MACRONIX INTERNATIONAL CO., LTD.

Product/Process Change Notice

PCN # P-2210-0002

Subject: 75nm Serial NOR Flash, MX25R3235FZNILO, to be manufactured at Fab 2 (8" fab).**Change Category:** Additional Manufacturing Site**Affected Products:**

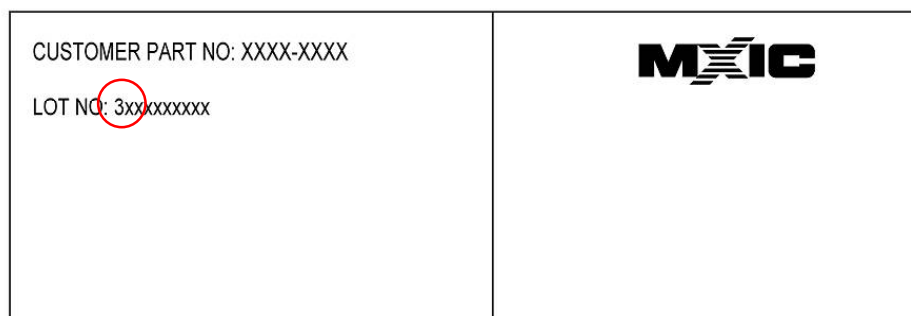
- 1). Unique ID Data (UID) stored in the Serial Flash Discoverable Parameters (SFDP) can identify the wafer Fab locations. Please refer to the datasheet description regarding "Read SFDP data sequence" for details, read from address "1E1h", if the data is "F5h" it means the device is from Fab 5, if data is "F2h" means it's from Fab 2.
- 2). Package top marking with lot# can also identify the wafer Fabs, lot# starts with number "2, 3, or 5" means the device is from Fab 2, whereas Lot# starts with number "7,8, or 9" means the device is from Fab 5 (see below marking illustration as an example, lot# starts with a "3" means it is from Fab 2)
